## Accessibility Survey

### City of Downey Seaaca Street - Pangborn Avenue To Cul-de-sac

Date of Inspection  
12/7/2016

**Sidewalk West Of Cul-de-sac @ 33.921811250802, -118.111967146397**

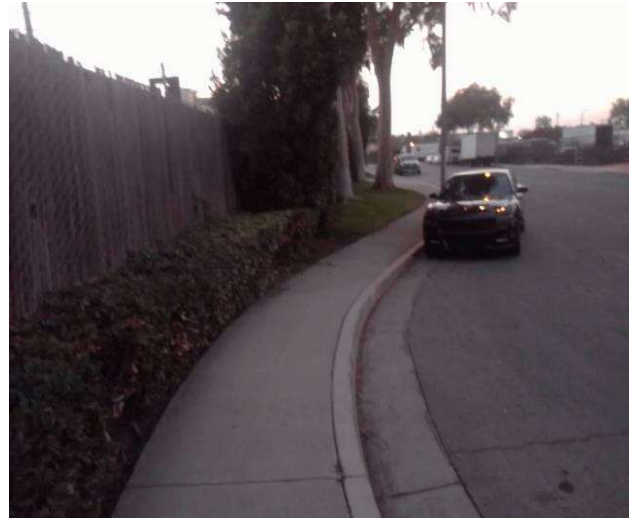
Sidewalk cross slope is not compliant.

**On-Site Finding** 4.00 percent for 52.00 feet

Repave the sidewalk surface with the recommended cross slope.

Recommendation Up to 2.08 percent
